# CITY PLANNING COMMISSION

APPLICATION: Variance to locate a proposed outdoor dining trellis within the 50 foot building setback for a proposed fast food restaurant fronting Stockton Boulevard on 0.5+ partially developed acres in the General Commercial (C-2) zone.

LOCATION: 5200 Stockton Boulevard

STOCKTON BLVD. SACRAMENTO, CA.  
**PATIO & TRELLIS DESIGN**

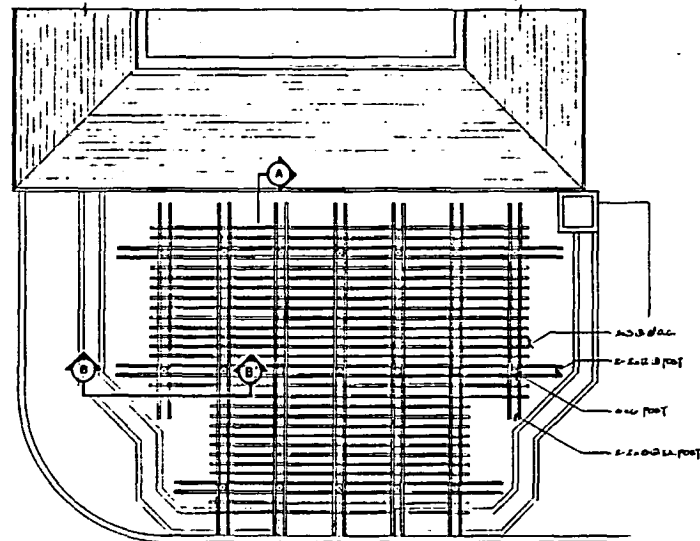
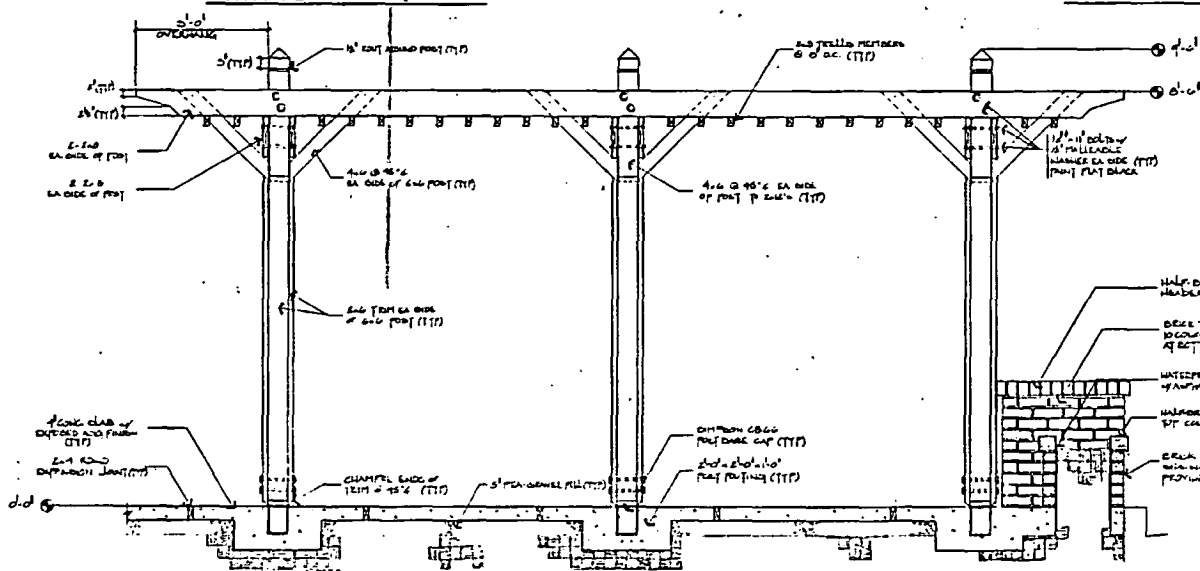
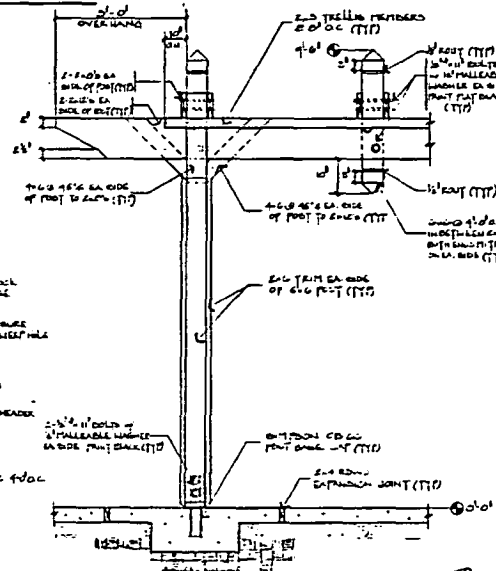
The applicant proposes to establish an outdoor eating area for 14 seats on a patio in front of the restaurant. The applicant proposes to construct a redwood trellis to provide the outdoor patio area with shade. The trellis will be located a distance of twenty-five feet from the front property line. A variance must, therefore, be obtained to encroach into the 50 foot setback area.

2. The applicant proposes to surround the outdoor patio area with a raised brick planter planted with climbing vines and shrubs. The proposed trellis and landscaping treatment would be an attractive feature to the subject restaurant. The staff is supportive of restaurants which encourage outdoor dining facilities as long as there are no conflicts with either pedestrian or vehicular traffic.
3. Staff supports the applicant's variance request in that the proposed project would provide an attractive outdoor dining facility with effective landscape treatment to an area that is normally developed with asphalt surfaced parking lot. There is adequate parking on site to meet the parking requirement for both the indoor and outdoor seating area.

The 50 foot setback requirement is intended for fully enclosed structures. The subject trellis is an open canopy with no permanent walls. The basis to support a variance is that the 50 foot building setback renders approximately one-third the project site unbuildable. Approval is based on the plans as submitted and enclosure of the patio area at a future date will not be permitted.

CONDITION: Approval is for plans as submitted. The trellis shall not be enclosed at a future date.
